# Service Bulletin

## SPECIAL COVERAGE

**SUBJECT: Special Coverage Adjustment – Improperly Formed Hood Panel Clinch Joints**

**MODELS: 2014 Buick Verano  
2014 Chevrolet Sonic**

### **Verano Service Locations**

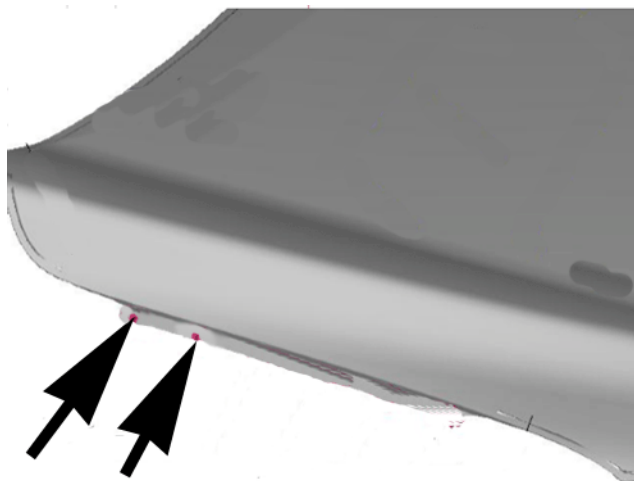
1. Remove the hood from the vehicle. Refer to *Hood Replacement* in SI. Place the hood on a suitable work surface.
2. Remove the hood insulator. Refer to *Hood Insulator Replacement* in SI.
3. Locate the clinch joints to be serviced, they are circled in white below.

Dealers are to drill out the identified clinch joints and replace them with rivets. The repairs will be made at no charge to the customer.
